**COMMUNITY DEVELOPMENT DEPARTMENT
PLANNING DIVISION
DRB PRE-APPLICATION STAFF MEMO**

RE: Coffee Shoppe & Car Wash DRB PreApp (PL-DR-22-0007)
Meeting Date: February 24, 2022

GIG HARBOR CHEVRON GRINDSTONE COFFEE SHOPPE AND CYBER EXPRESS CAR WASH

TITLE: BUILDING ELEVATIONS (90' TUNNEL)
DATE: 01.18.2022 SCALE: 1/16" = 1'-0"

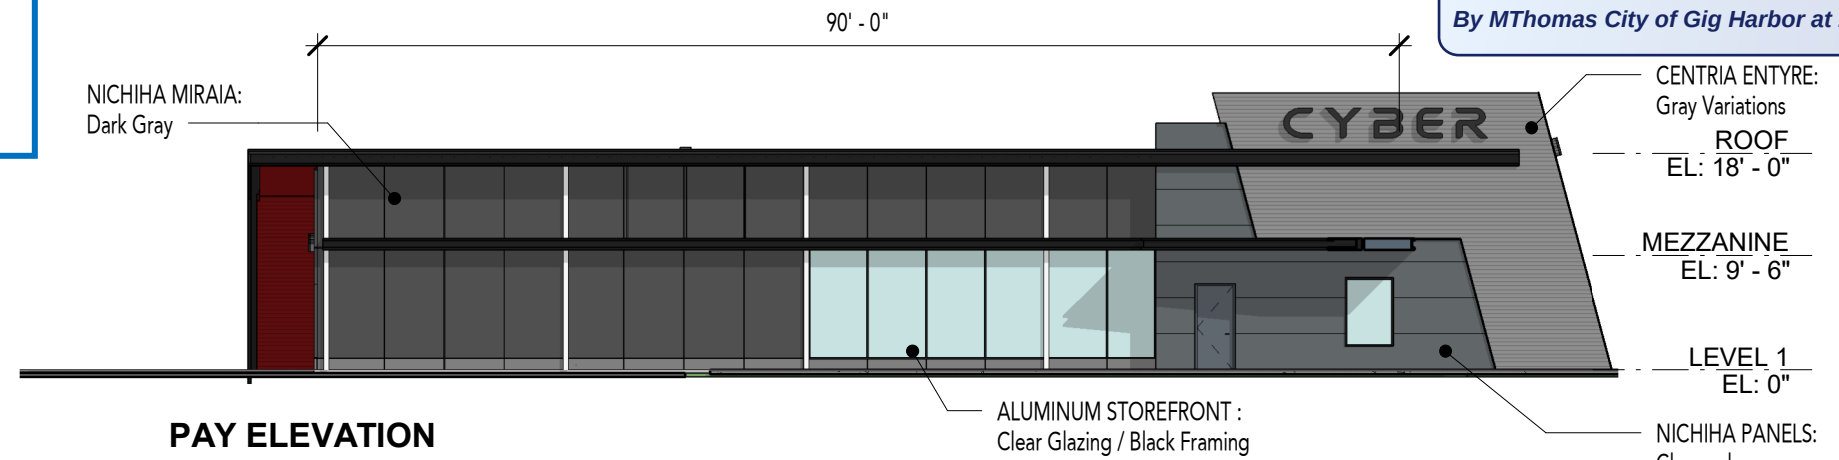
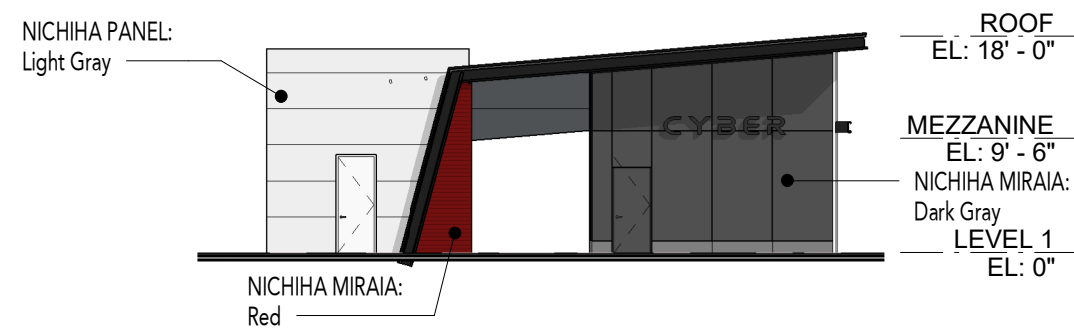
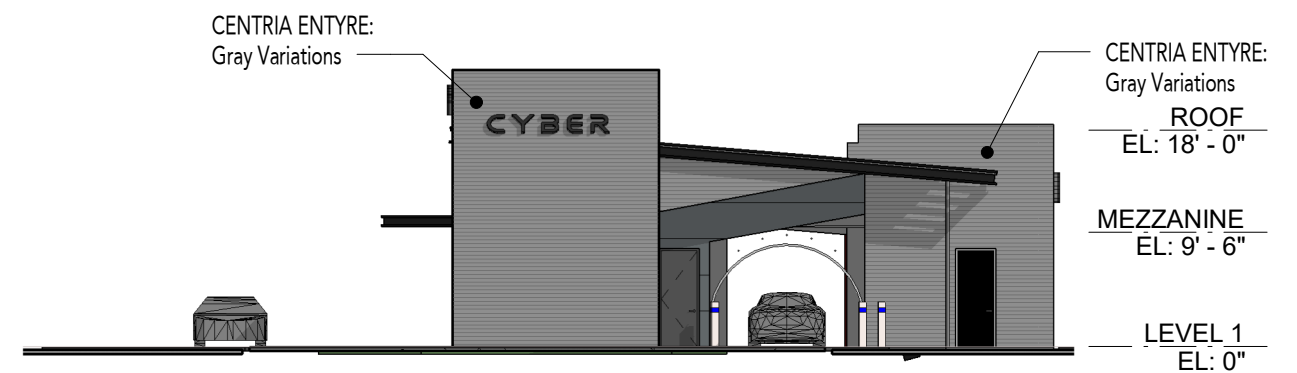
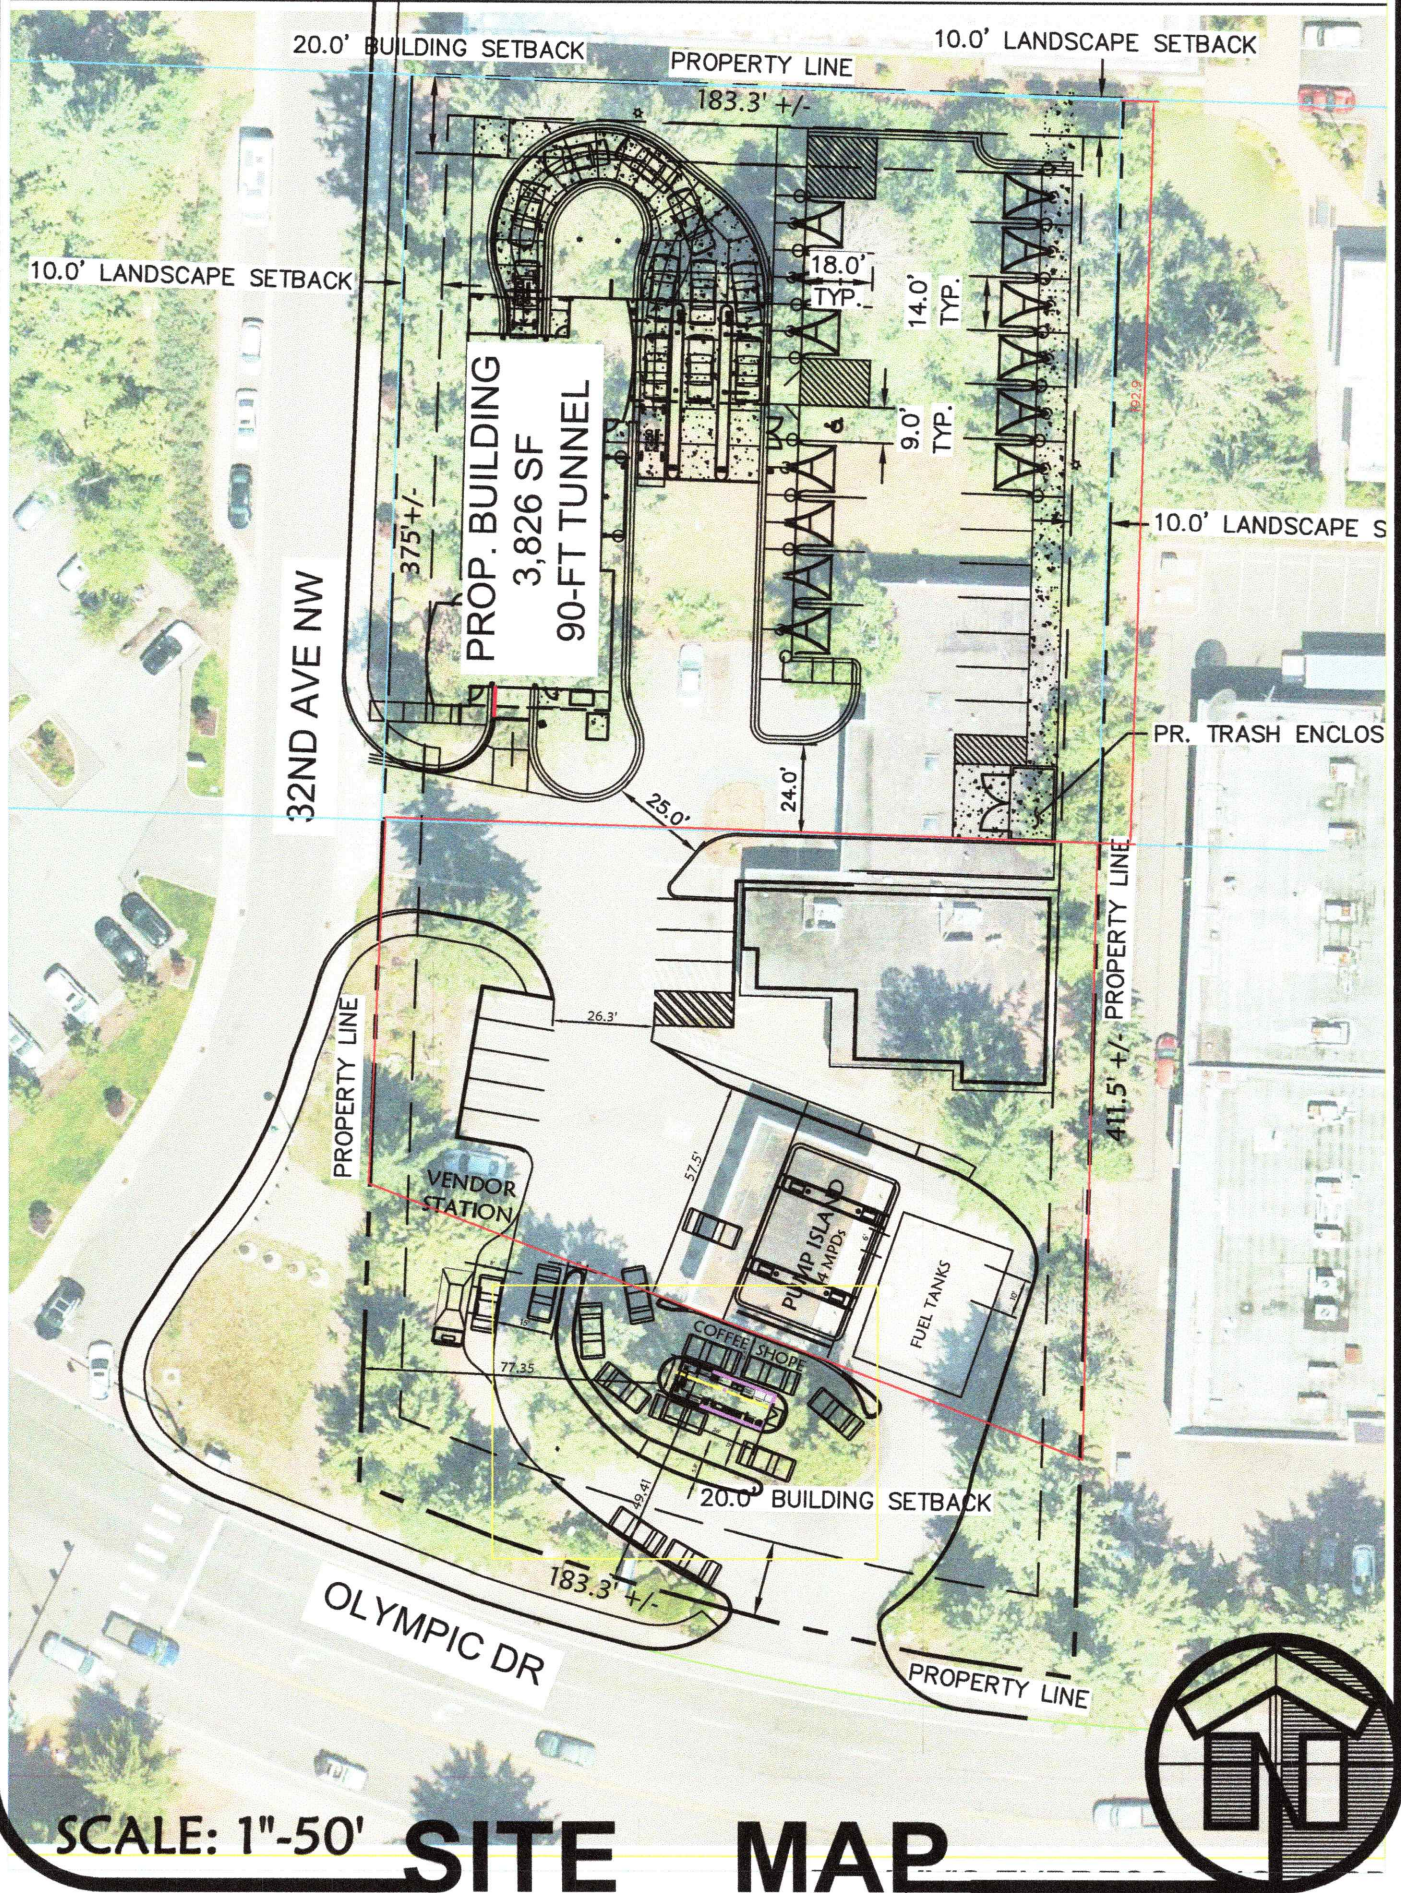
Mass and Scale; The proposed design does not appear to conform with the standards of GHMC 17.99.380.

Prominent facades: The standards of GHMC 17.99.400 are applicable to all nonresidential development: Provide consistent architectural interest to all prominent facades, and; apply all design criteria to prominent facades.

Siding and trim: Siding materials are limited to horizontal lap siding (of any lap design) made of wood or cement-like materials; shingles made of cedar or cement-like materials; board and batten (or panels with similarly spaced battens); brick, stone (real or cultured), nonscored, split-faced or ground-faced block (CMU). Stucco, tile, terra-cotta, concrete, spandrel glass, sheet siding (e.g., T1-11), corrugated metal panels and smooth-faced or scored concrete block may be used as accent materials, not to exceed 20 percent of any given facade. Standing seam metal siding with separately attached battens (with proportions similar to board and batten siding) may be used in gables only, or on up to 20 percent of any given façade.
